**BEFORE THE INDEPENDENT HEARINGS COMMISSIONER APPOINTED BY
THE CHRISTCHURCH CITY COUNCIL**

IN THE MATTER of an application for resource consent under section 88 of
the RMA by Cambridge 137 Limited for demolition of a
heritage building and construction of a hotel

**STATEMENT OF EVIDENCE OF GRANT ARMSTRONG ON BEHALF OF
CAMBRIDGE 137 LIMITED**

ARCHITECTURE

Figure 1 Typical Floor Plans with Setbacks

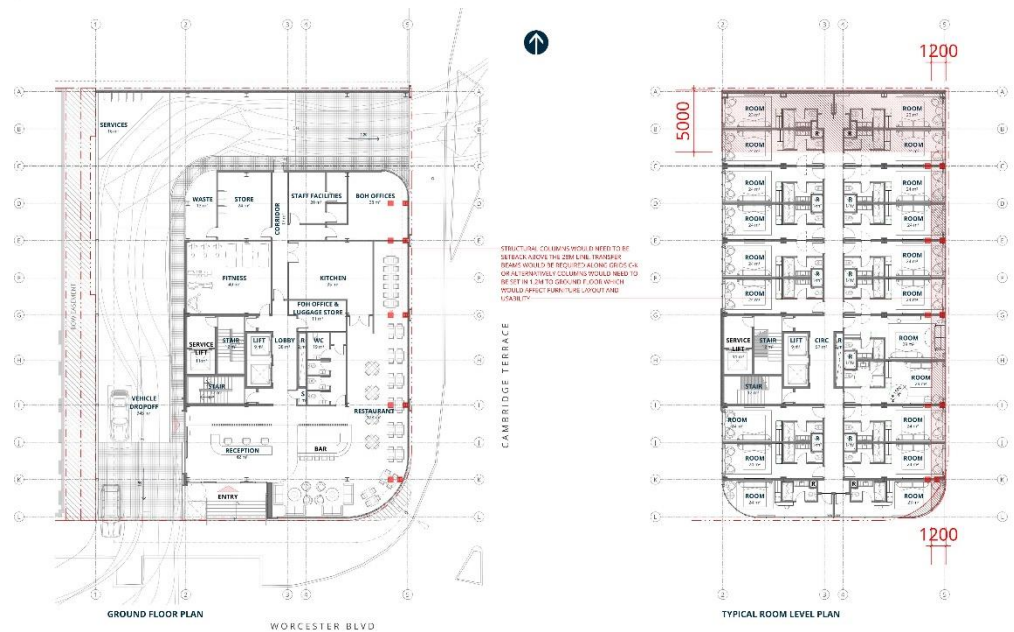
- (a) A setback on the eastern side of the building of 1.2m from 28m above ground level (level 7 of the building), which Mr Blair suggests could be used as a balcony for the 7th floor rooms; and
- (b) A setback of 5m on the northern side of the building from 32m high (level 9 of the building), which Mr Blair precludes from being used as a balcony for the 9th floor due to privacy concerns.

- 68 While the structural grid remains unchanged for the building generally, the setbacks would require the realignment of the structural grid along the eastern (Cambridge Terrace) side of the building. To achieve this, either a structural cantilever of the lower levels below the 28m setback would need to be installed or the building would need to be redesigned to transfer the structural loads at the 28m level. Both structural options would need to accommodate the additional complexity of the reaction of structural asymmetry reaction under seismic loads. To achieve sufficient structural strength the depth of the structural beams in this zone would increase. This would result in reduced services zone and potential reduction in ceiling heights to the guestrooms. These structural options, subject to further structural engineering design analysis, introduce design complexity and additional structural costs.

- 69 The setback of structural columns by 1.2m to provide the required structural support effects the layout on the first floor. Effectively it changes where the structural columns need to be which effects the flow and openness of the first floor. The openness of the first floor is critical to ensuring efficiency and human connectivity – which in turn effects human scale.

Figure 2 Intersecting Double Curve Curtain Wall Detail

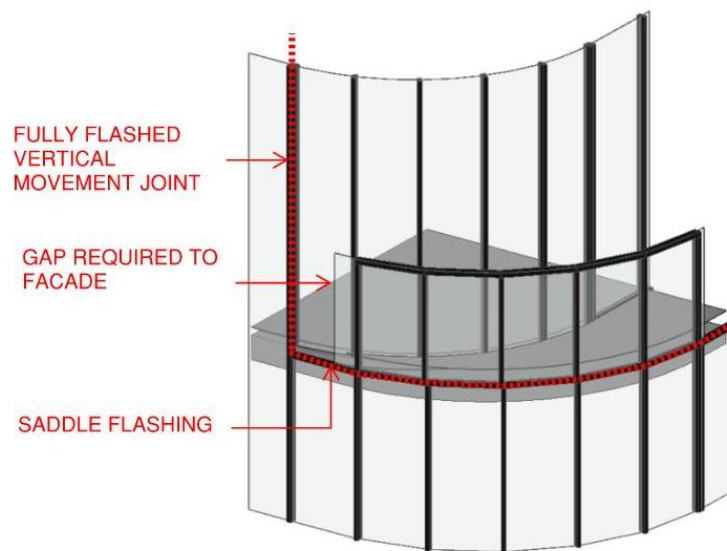
- 72 Further, the 1.2m setback on the eastern façade of the building will have a direct impact on the technical requirements to reconcile the physical junction of two curving corners. In the current design, the bottom floor has a greater curve joining the eastern and southern façades than floors two and upwards. Introducing a setback would require the introduction of a third curve for the top floors of the building façade.

- 73 This 'intersecting double curve' geometry will require a bespoke curtainwall mullion design as it is non-standard detail not supported in any industry suppliers details. It would include a fully flashed vertical movement joint and saddle flashing. The resulting façade detail is visually unsatisfying and fundamentally conflicts with the sleek and simple curtain wall design. This junction would be designed out in normal architectural design development as it creates a façade weathertightness risk, increases cost, and is visually inconsistent.

Figure 3 Typical Guestroom Layout with Setbacks

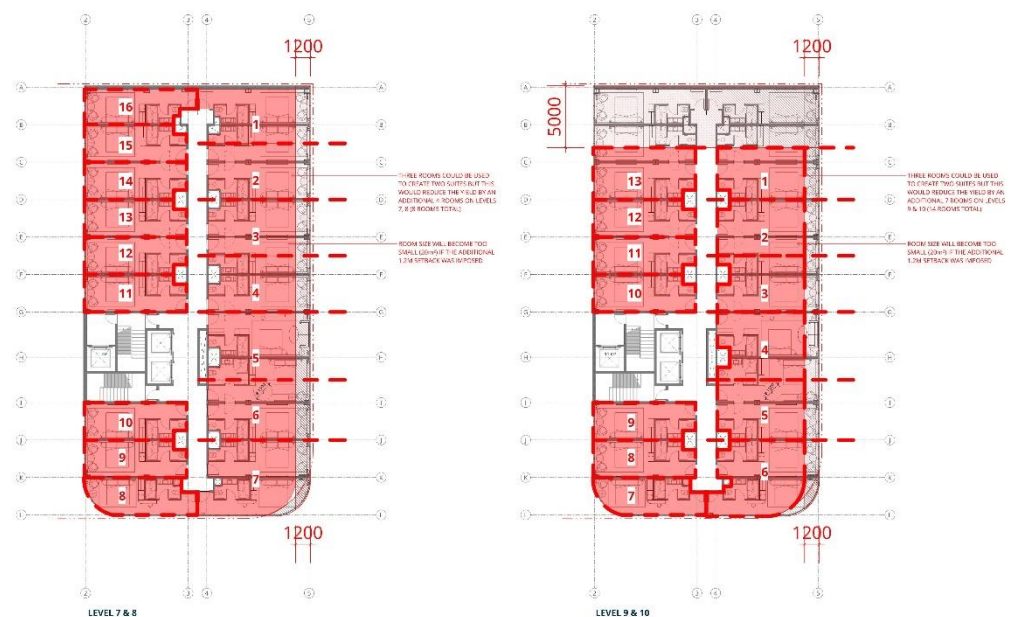
- 77 The most obvious outcome of the recommended setbacks is the reduction in guestroom numbers. Four rooms will be lost for every floor the 5m setback is imposed upon (eight rooms in total). A further four rooms would be lost on every floor the 1.2m setback is imposed on as the resulting reduction in room size would bring the rooms on the eastern side below industry standard and would require combining rooms. The 1.2m setback would result in the loss of a further 16 rooms. Between the two setbacks a total of 24 rooms would be lost. This represents 12% of the operational capacity of the building.

- 78 Beyond the base loss of rooms, the required reconfiguration to accommodate the setbacks would introduce significant inefficiencies.
- 79 First, the reconfiguration of rooms would affect the design of the plumbing services. The plumbing services are designed to be mirrored on each floor to ensure operational and construction efficiency. This type of efficiency minimises the risk of plumbing issues which may arise ensuring the functional needs of the building.
- 80 Second, hotels and hotel staff rely on a 20 rooms per floor and mirroring floor layouts to ensure efficiency of servicing the rooms. The proposed setbacks and resulting effect on the configuration on the rooms reduces the ability for the building to provide this operational functionality.

Figure 4 Balcony View from Room

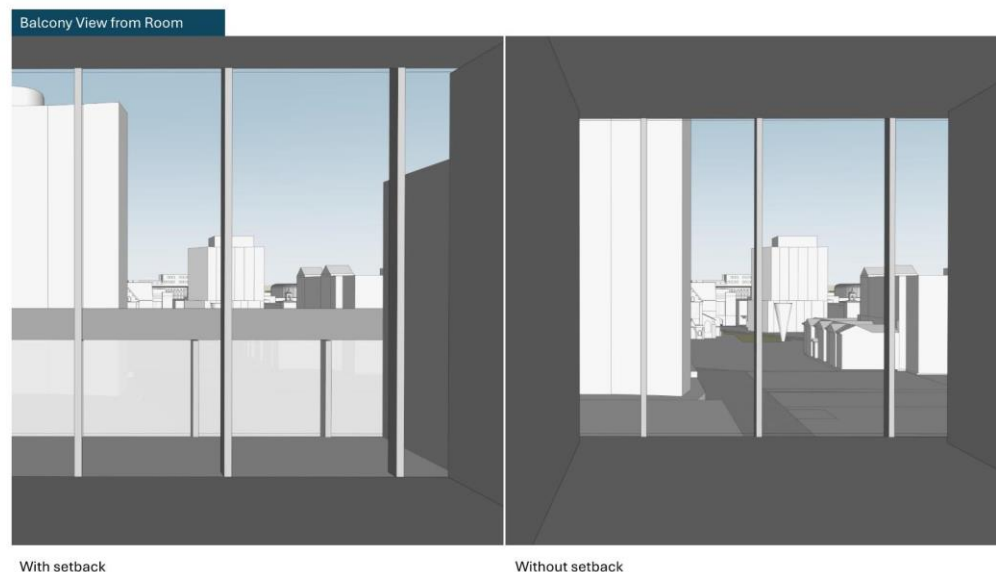
- 81 Mr Blair suggests the 1.2m setback could be used as a balcony (although he does not recommend the 5m setback being used as a balcony for privacy reasons). The provision of balconies is highly unconventional for a standard city four-star hotel (balconies are more typical in resort hotel settings, especially in sub-tropical and tropical environments). Balcony spaces are rejected by hotel operators in this context as fundamentally not providing a return on investment as they result in:

- (f) Increase the effect of wind and are uncomfortable to use when it is windy (in this case the balcony would be on the eastern side of the building which faces the prevailing wind); and
 - (g) Are grossly underutilised by guests.
- 82 Even in buildings where there is a pleasant outlook (such as the proposed hotel), balconies are typically rejected by four-star city hotel operators as they reduce the quality of the view from inside the room as the room is effectively setback from the edge of the balcony. This introduces a visual barrier to the view. Instead, large glass windows are typically favoured as they provide unimpeded views and human connection to those views. In the proposed building this provides connection to Cambridge Terrace and to Otakaro Avon River.

Figure 5 View from Gloucester Street

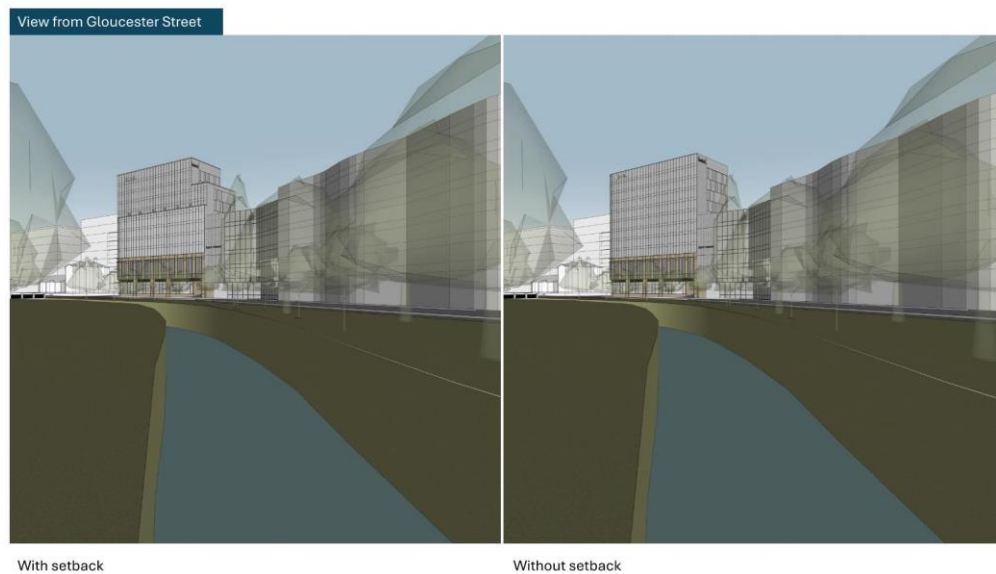
- 83 In addition to the functional and operational effects, the proposed setbacks have aesthetic effects in terms of the scale and look of the building.
- 84 Mr Blair engages with “scale” at the top of the building (which is rarely seen or noticed by the public) rather than at the ground level which is where the public predominantly engage with a building and notice its scale. Very large buildings maintain human scale if their lowest levels are designed to engage the public. Mr Cleese discusses this aspect in

- 85 When viewed from the Worcester Boulevard western approach, the notch to the tower resulting from the 5m setback on the northern façade of the building presents as a ‘missing piece’ with no architectural logic or reference. This is detrimental to the sleekness and sophistication of the

- 86 When viewed from the Worcester Boulevard south elevation, the 1.2m setback presents an irregular architectural corner profile which detracts from the soft strength of the vertical curved corner of the proposed tower, and weakening the strongest element in the architectural hierarchy.
